11-5-10
Letter # 10409

RE: 1054 NE 97th St, Seattle
Not Engineer of Record
SIP Ledger to Wall / Roof Ledger

ROOF PLAN & SECTIONS
PANEL LAYOUTS & PBS DETAILS

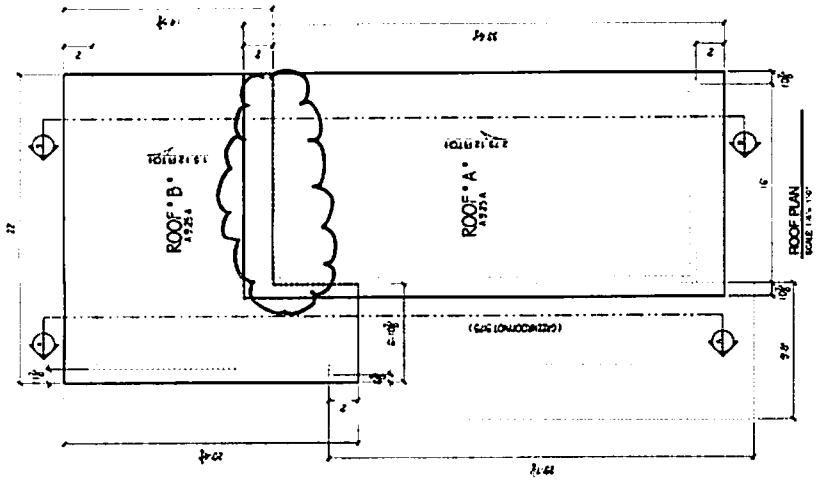
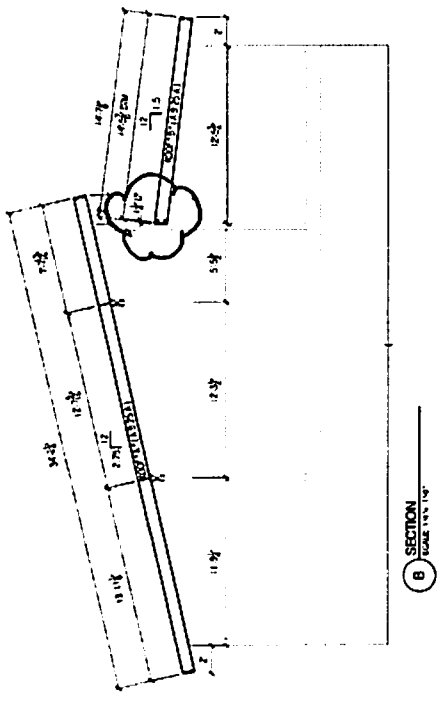
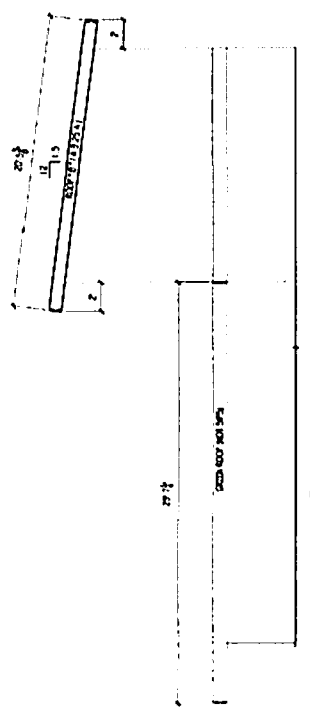
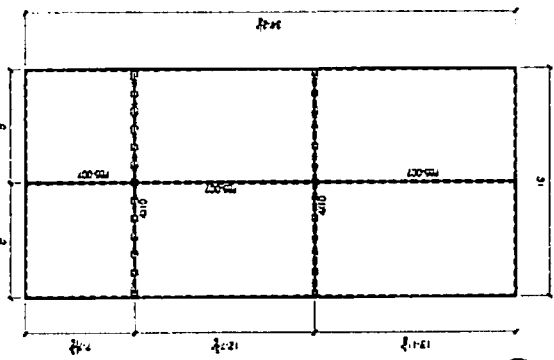
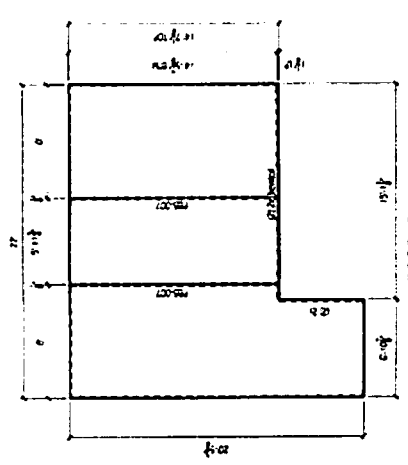
Per the attached plan view there is 7' of tributary roof loading on the connection. For each connection this roof load is $7 \times (15DL + 30SL) \times 2' = 730$ pounds. The 4 SDS screws have a capacity of 1000 pounds.

ROOF LEDGER ROBERT RICE

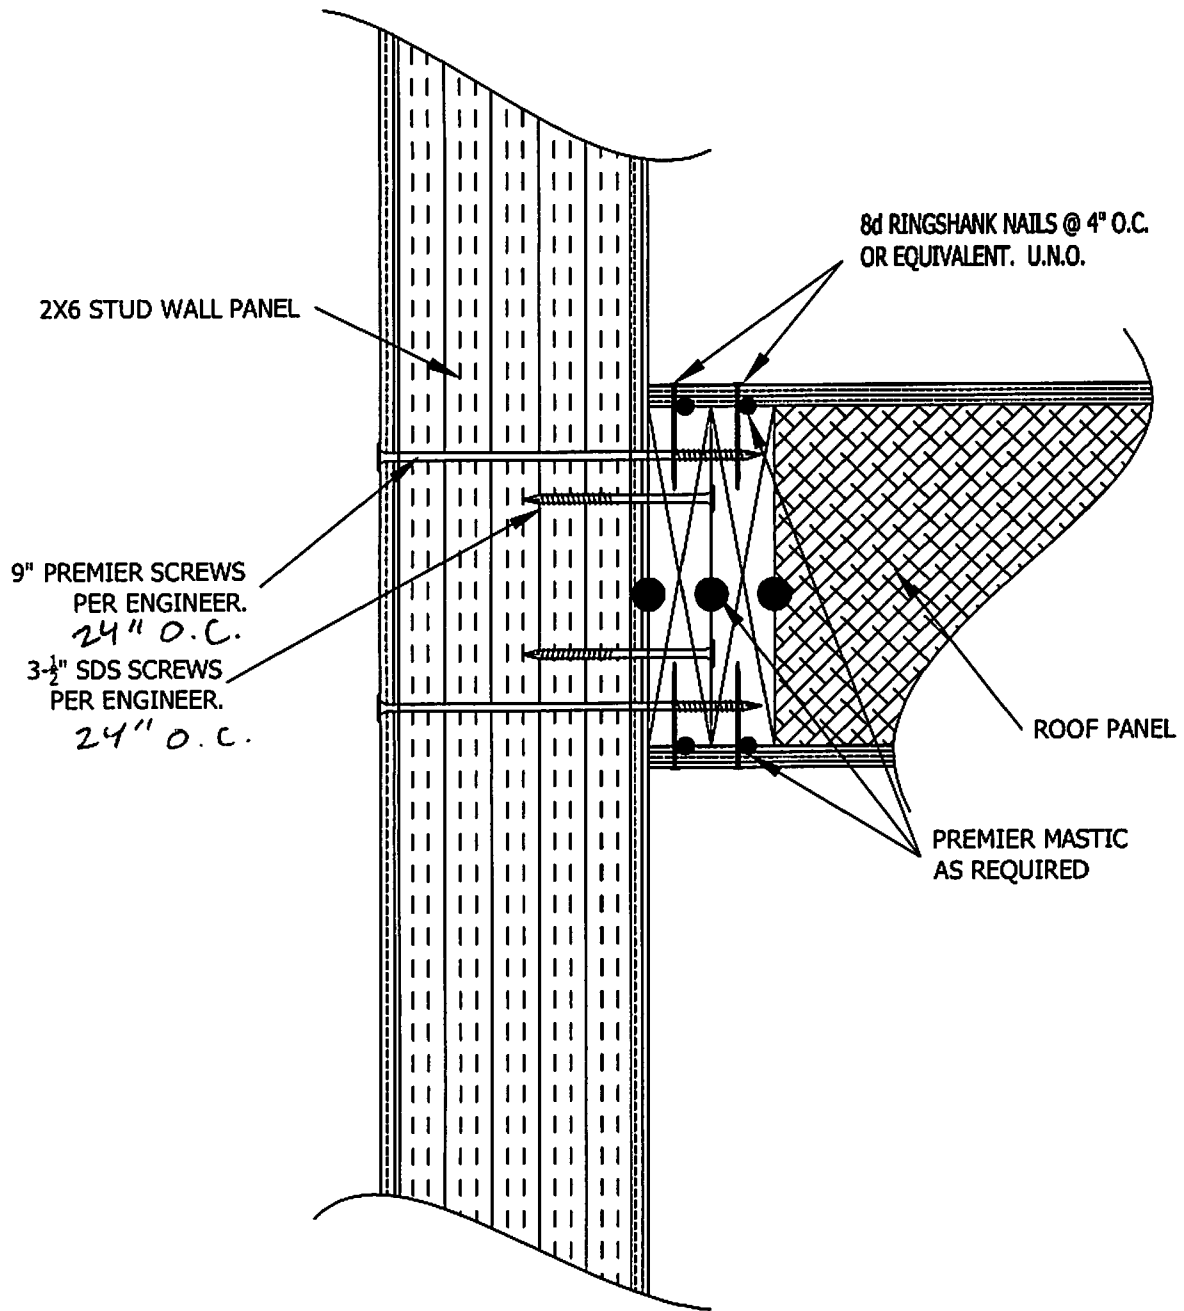
I have reviewed the attached ledger to wall connection provided by the client. The ledger to the wall is connected with (2) 8" SDS screws spaced 24" on center through 2x6 studs from the inside of the structure. The edge nailing of the 10" SIP panel should be 8d nails spaced 4" on center.

In my professional opinion the attached roof connection can carry the loading shown on the attached roof plan view.
